SUBJECT: Addendum to the Stage 2 Abatement Plan Modification (ST-106), Bulk Fuels Facility, Kirtland Air Force Base (KAFB), NM

Kirtland AFB Stage 2 Abatement
Plan Modification Addendum
Kirtland AFB Bulk Fuels
Storage Facility (ST-106)

Location of Proposed Groundwater
Monitoring Well at the Kirtland AFB
Bulk Fuels Storage Facility (ST-106)

Stage 2 Abatement Plan Modification Addendum, Bulk Fuels Facility (ST-106), Kirtland Air Force Base (AFB), New Mexico

Figure 1

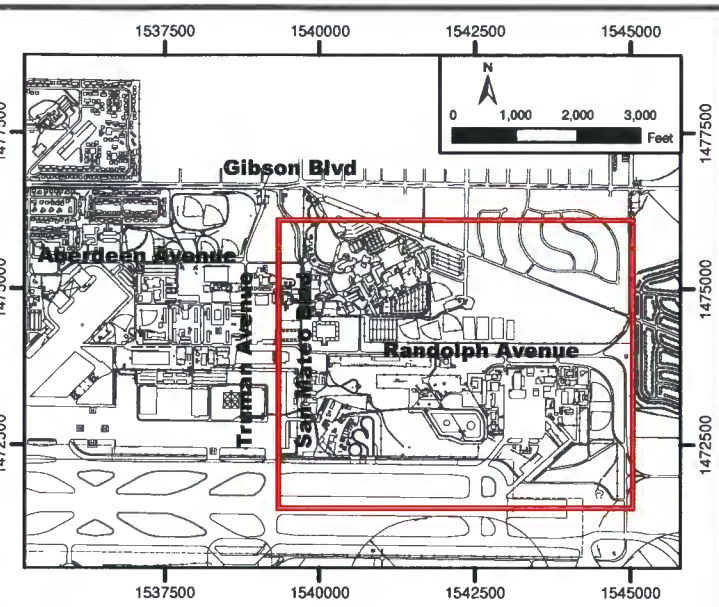
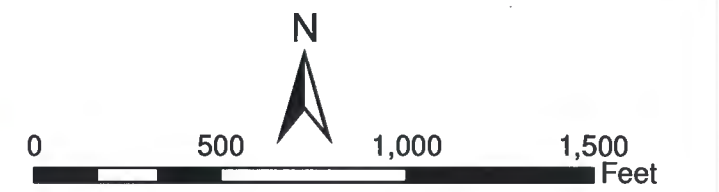
It is currently recommended that the proposed borehole adjacent to Tank 2422 be advanced to the groundwater table and completed as a groundwater monitoring well. Installation of a groundwater monitoring well at this location will provide a complete assessment of possible contamination in the vadose zone as well as a valuable groundwater monitoring data point. The final decision to complete the Tank 2422 boring as a groundwater monitoring well will be dependant on the findings at one of the other proposed boring/well locations, KAFB-1066. The rationale and installation details for KAFB-1066 are discussed in detail in the main body of the *Stage 2 Abatement Plan Modification*. As the KAFB-1066 investigation activities proceed Kirtland AFB will discuss the field data and findings with New Mexico Environment Department (NMED)-Ground Water Quality Bureau (GWQB) staff and the final installation details for the Tank 2422 location will be agreed upon.

3. Figure 1 presents the proposed location for installation of the soil boring/monitoring well in the Tank 2422 area. The final groundwater monitoring well designation has not been determined and will be contingent on the progression of other monitoring wells that will be installed during the same field mobilization. Anticipated investigation activities for the area adjacent to Tank 2422 are briefly described in the following sections. Overall, sample collection and well installation techniques will utilize the same field procedures outlined in Section 3.3.1.1 of the *Plan Modification*.

- The borehole will be installed using the downhole air rotary casing hammer (ARCH) drilling technique. Soils will be geologically logged at 10-ft intervals from either split spoon samples or returned drill cuttings by the onsite hydrogeologist. During drilling operations, subsurface soils will be collected every 20-ft using a split spoon sampler for a total of roughly 24 split spoon
